Author's response by Justus G.V. van Ramshorst et al.

This document contains a point by point reply to review #1 and #2 of “Lower-cost eddy covariance for CO₂ and H₂O fluxes over grassland and agroforestry” by Justus van Ramshorst et al. (DOI: <https://doi.org/10.5194/amt-2024-30>).

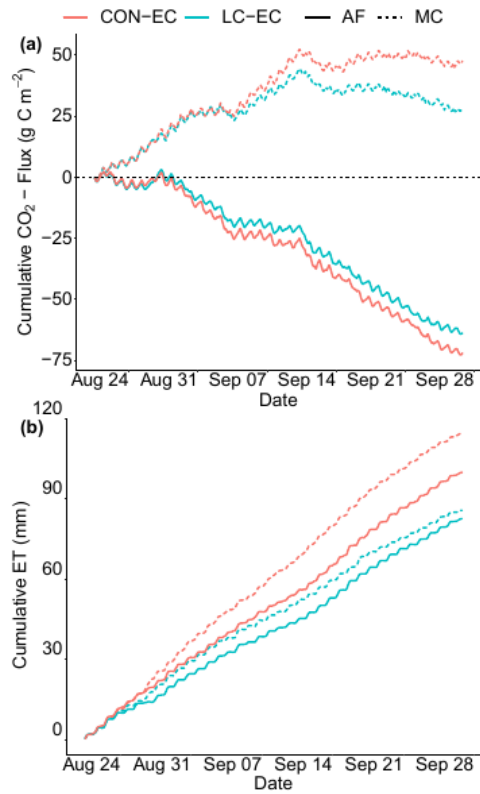
3. Fig 11 is not gap-filled and loses a lot of value that way. Can a simple gap-filling approach (e.g. with REDDYPROC) be used to assess the impact of these site and instrument differences in a real use-case?

We agree that gap-filling this figure adds value and therefore gap-filled the data for the figure. The agroforestry datasets are unfortunately too short for REddyProc (< 3 months), but instead we used the XGboost gap-filling method by Vekuri et al. 2023. A description of this additional processing step is added to method section 2.3.4. and reads as follows:

The gap-filling changes the results of the simultaneous cumulative fluxes, as shown below, therefore section 3.4 – Agroforestry versus grassland now includes the updated Figure 10 (previously 11) and is rewritten as follows:

Section 3.2.2 scatter plots:

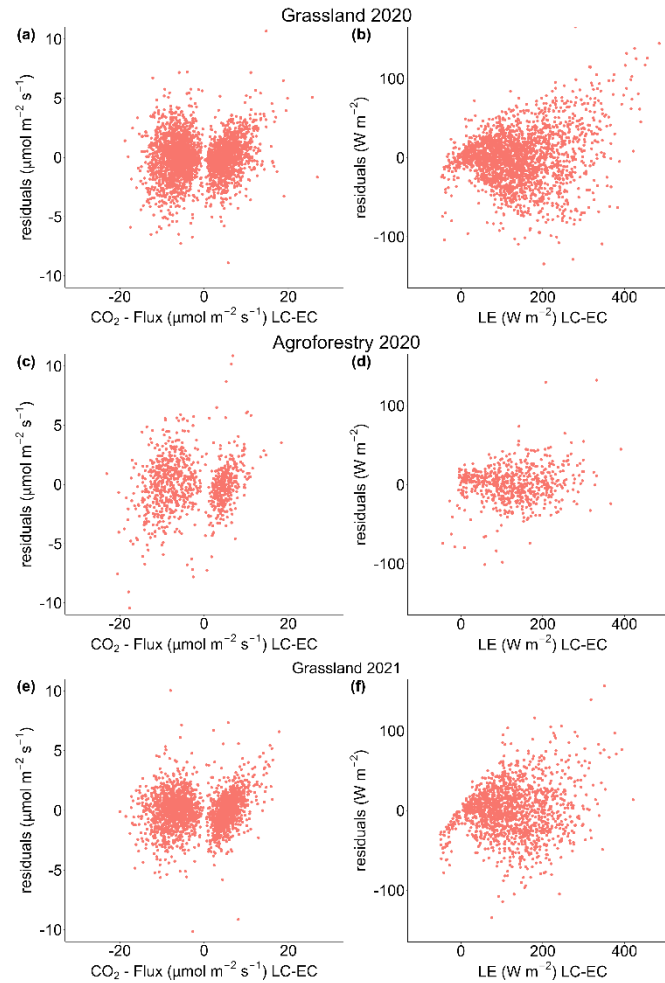
6. L198 have the residuals of the regression always been tested for normality?

We plotted for the data from Fig. 4 the residuals vs. the fluxes (see figure below) and used a Shapiro-Wilk test. It shows that for CO₂ and LE the residuals are not normally distributed (Shapiro tests, $p < 0.001$). The LE residuals are increasing with increasing LE flux (clearly visible in the scatterplots from Figure 4, especially at the grasslands). The CO₂ flux residuals are also not normally distributed, which confirms the different regressions for positive and negative fluxes (section 3.2.2.). To explicitly state this in the paper, we added a Shapiro-Wilk test description to the method section 2.3.6. and in the result section 3.2.2. we added that the residuals are not normally distributed as follows:

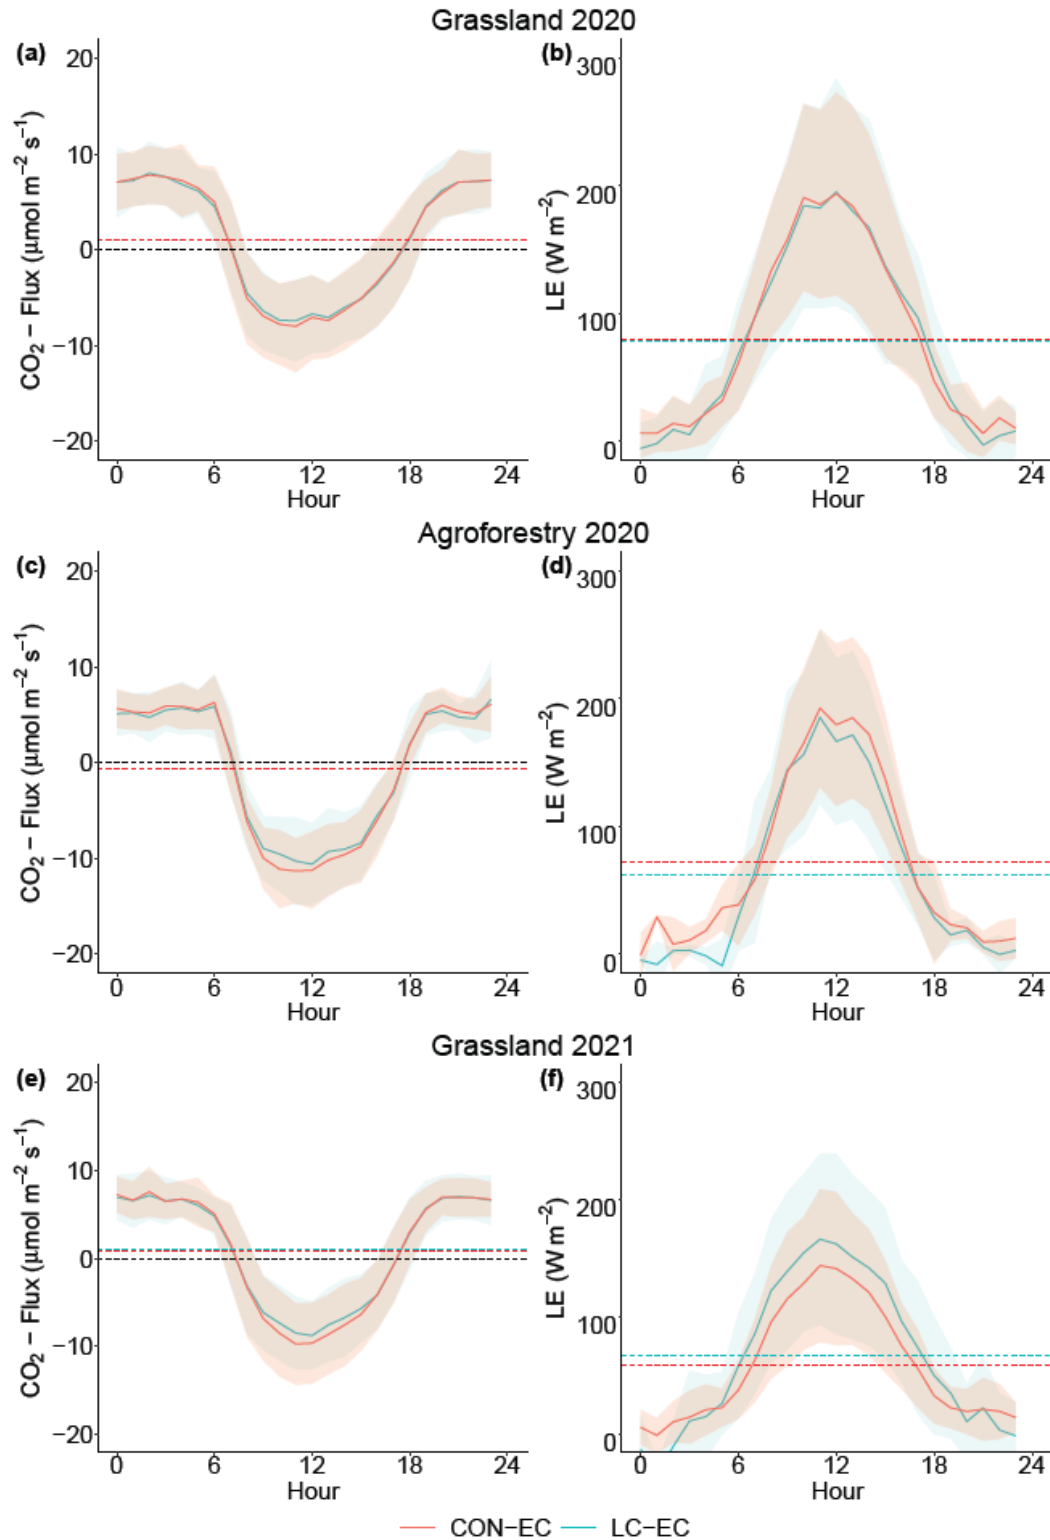
R12: Figure 3: Move the titles in the middle. The distance between the plot labels, (a) and (d), y-axis can be increased a little bit.

We have updated the figure accordingly

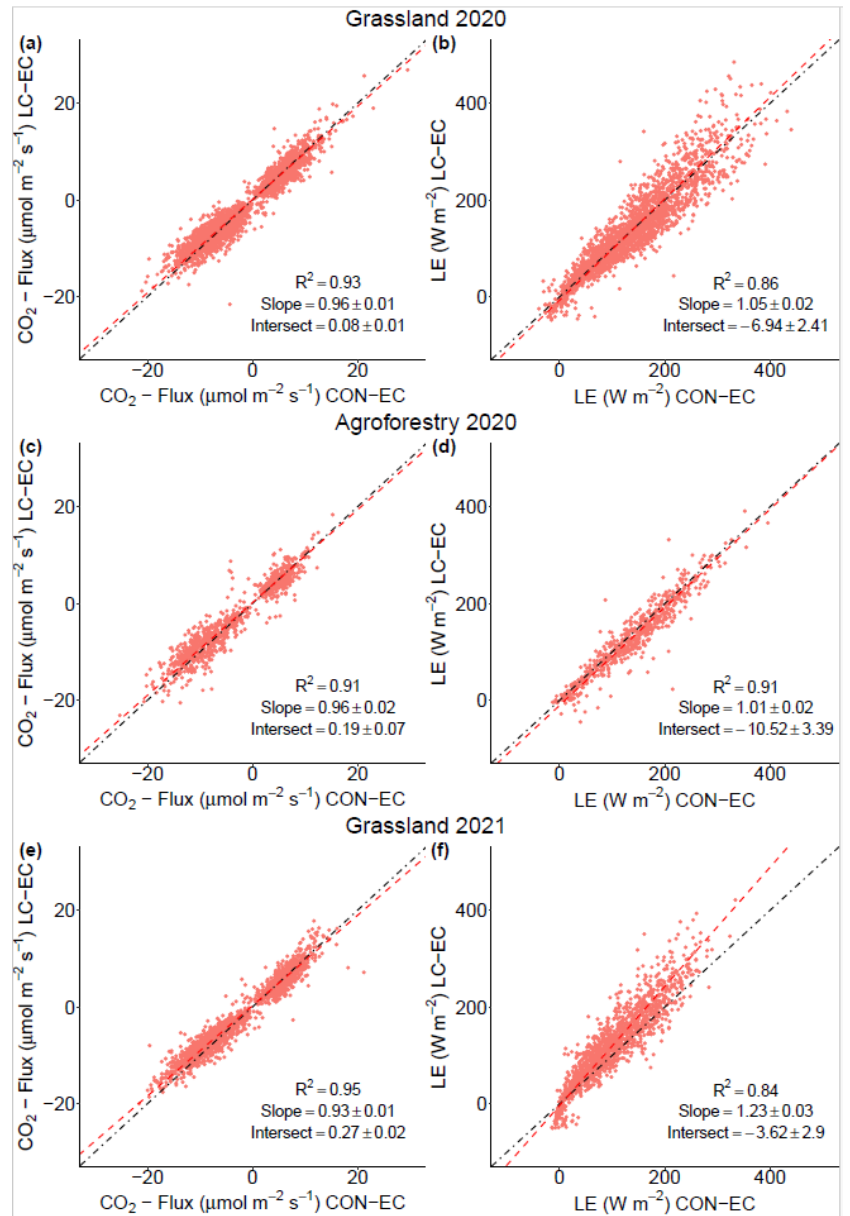
10. Fig 4 could include bias – both average and in different ranges (e.g. in the positive and negative FCO_2 ranges separately)

R13: Figure 4: Put the same titles on top of each row. There's a lot of information in the plot. I propose to summarize the information in a table.

According to us, an indication of the bias between the two EC setups is already visible by the slope (deviation from 1.0). For positive and negative fluxes, the slope/bias is mentioned in the text. Nevertheless, based on the suggestion from reviewer #2 we included a table summarizing all the information more clearly in addition to Figure 4.

We updated the titles inside the figure, and only left the linear interpolation results inside the figure. Additionally, we created a table with more detailed information and statistics, also including suggestions by reviewer #1. The text in 3.2.2. is slightly rewritten to state less numbers.

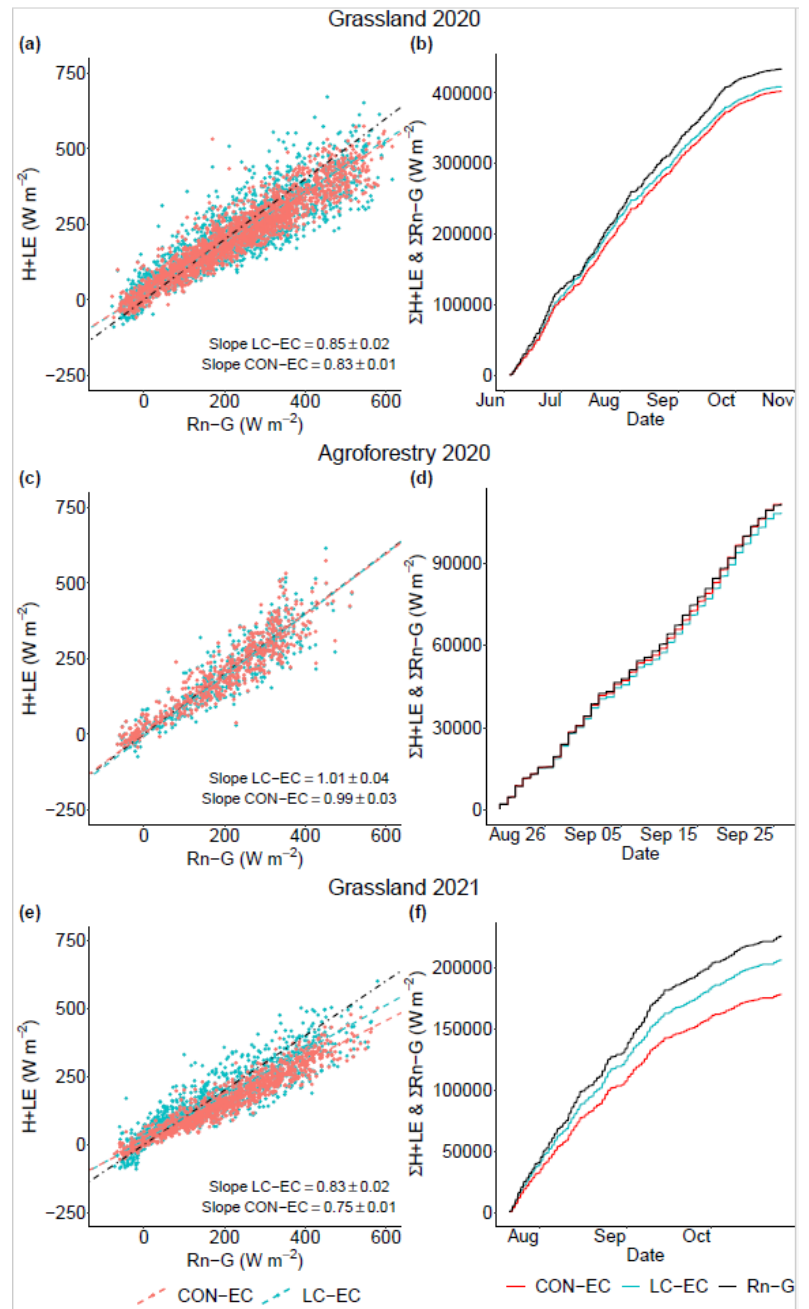
12. Fig 5a legend for LC-EC should be a green line; caption should have “light blue” as two words rather than one.

R14: Figure 5: Same as for figure 4. Also, the sections 3.2.2 and 3.2.3 are difficult to read because a lot of numbers are mentioned in text. A table can be helpful here. Align the format of the x-axes of (b), (d), and (f). Start and end date should be the same.

We updated the titles inside the figure, aligned the x-axes of the left and right column figures and only left the slope results inside the figure. The start and end date of the right column figures can't be the same as all three campaigns have different time periods and lengths.

As in section 3.2.2. (R13), we summarized the results of the EBC into a table in section 3.2.3. and slightly rewrote the text to state less numbers. The EBR ratio results are also summarized, but in another table in section 3.3.

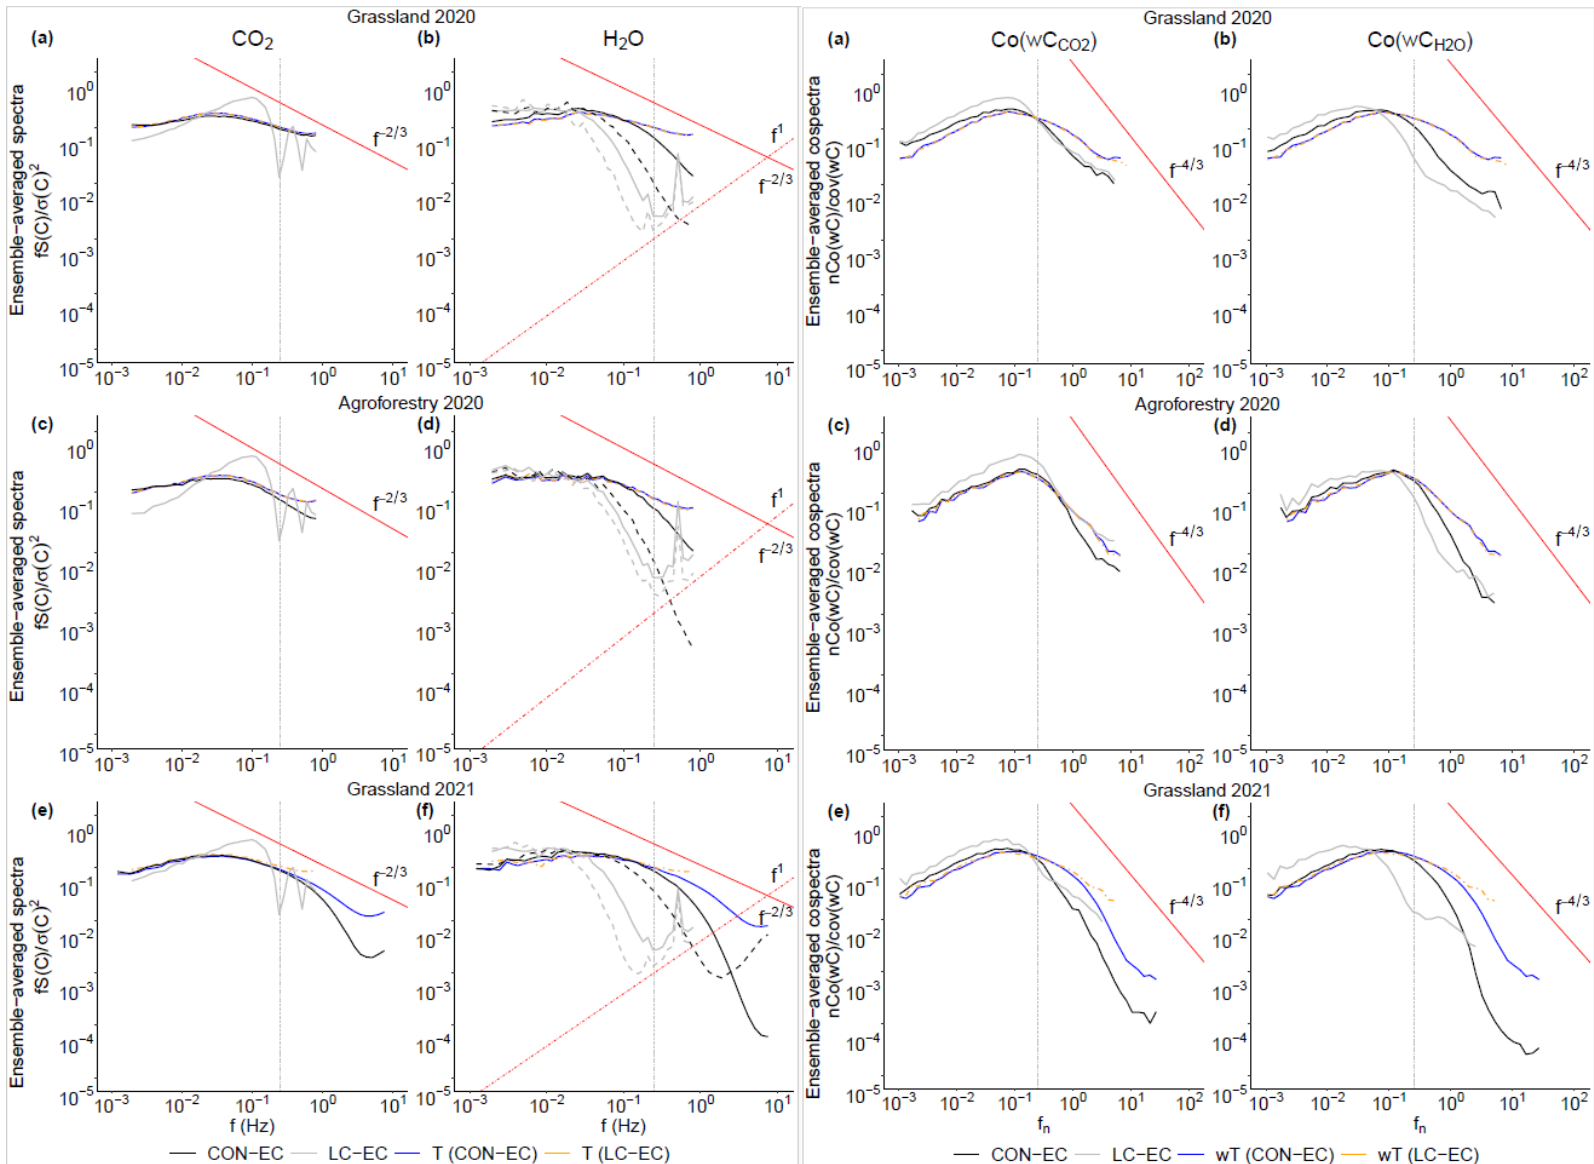
11. Fig 6 and likely elsewhere (e.g. Fig 7 and Table 3), “EC” is used rather than “CON-EC”. I’d prefer the latter to be explicit and consistent throughout the text.

R16: Figures 6 and 7: Add the ensemble averaged (co)spectra to (e) and (a) and add titles to each row. How many (co)spectra were used for averaging? Explain the inertial subrange in the method section. Choose a different color for the temperature (co)spectra. They are difficult to distinguish.

You are completely right; this must have been forgotten when implementing “CON-EC” instead of “EC” previously. We updated Fig 6 & 7 and updated two tables.

For Fig. 6 and 7 we have added ensemble averaged (co)spectra and titles to each row and changed the color of the LC-EC temperature (co)spectra. We defined the inertial subrange in section 3.2.4 by "In general, the spectra of the LC-EC show a stronger decay in energy content compared to the spectra of the CON-EC in the higher frequency range (i.e. inertial subrange)...". We created an additional table stating the number of CO₂ or H₂O (co)spectra used for the ensemble averages in Fig. 6 and 7.

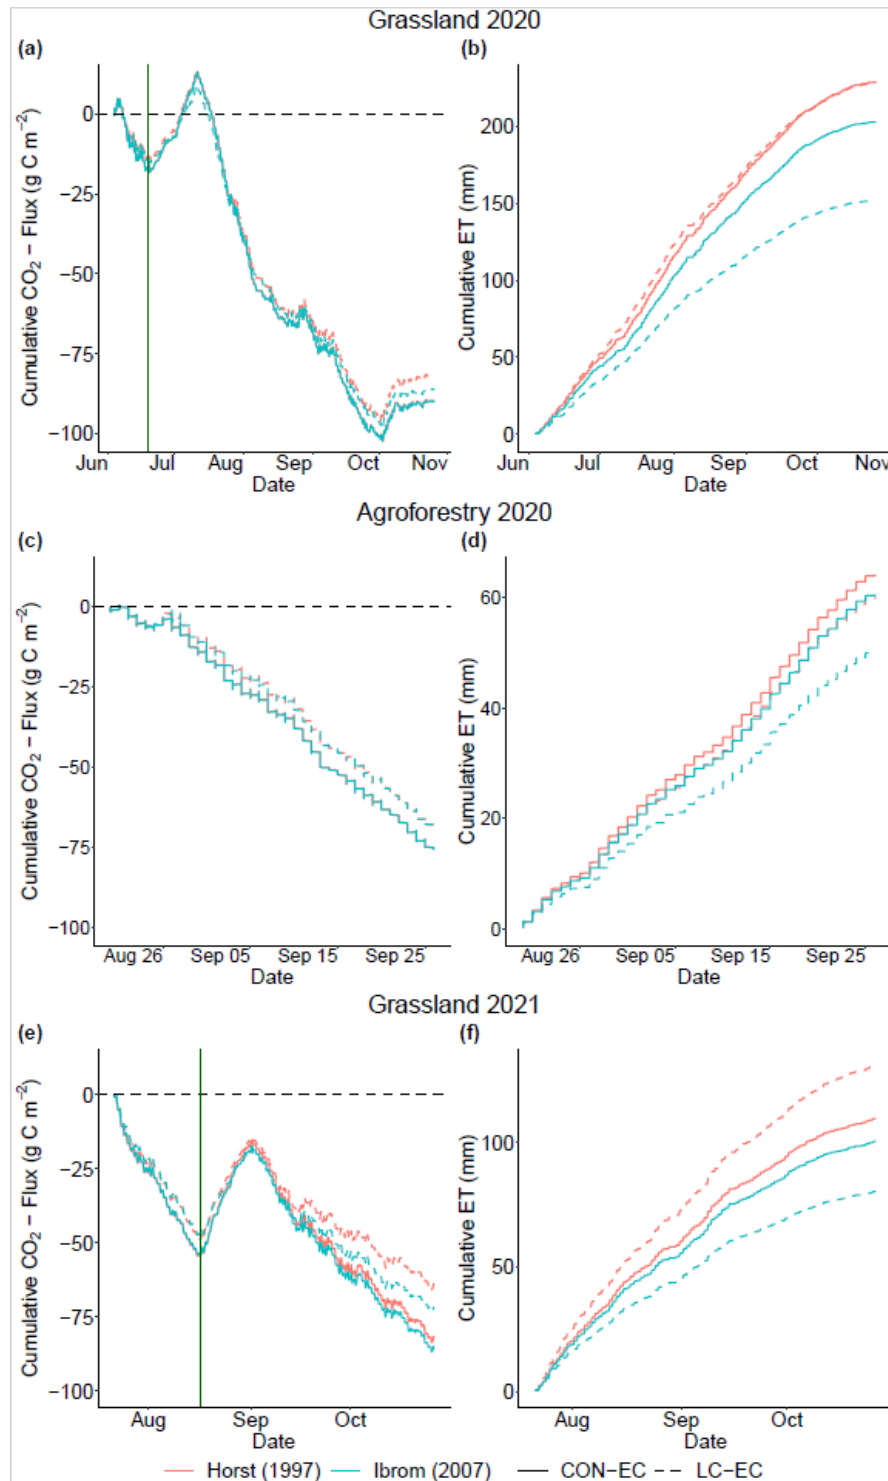
R17: Figure 8: is the figure needed? Since it is not referred in the discussion, put it in Appendix or supplement.

We removed this figure and it will be added as supplement.

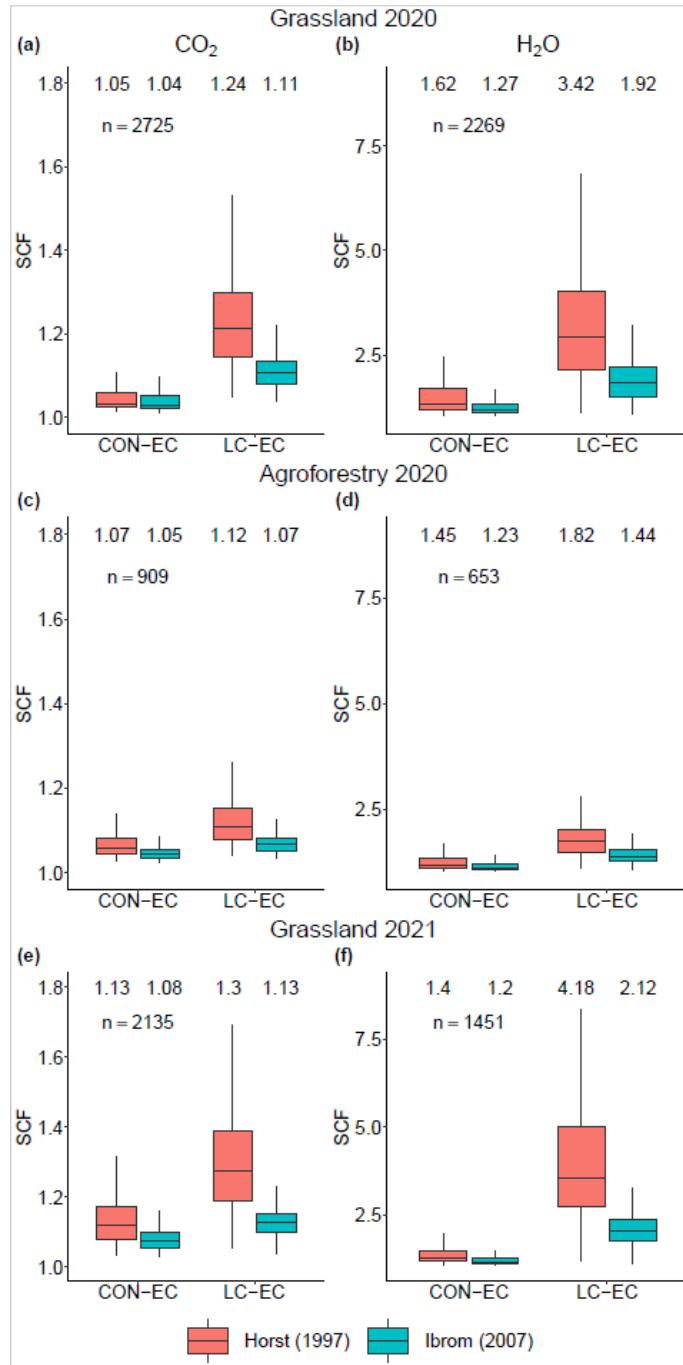
R20: Figure 10: Put titles on top of each row. The labels (a) to (f) look kind of large compared titles and labels. In the legend, the identifier for box plots, median and whisker, are hardly visible. Put numbers on top of each box showing how many values were used. Make the box borders, medians, and whiskers more visible. You may want to leave out the outliers. Then you see the range of the boxes better.

We have added titles to each row and decreased the size of the labels. The legend keys are increased for better readability. The number of measurements used for the four boxplots of each site are added to the figure (for each site all 4 boxplots use the same dataset size). We left out the outliers and improved the boxplot readability by increasing the linewidths.
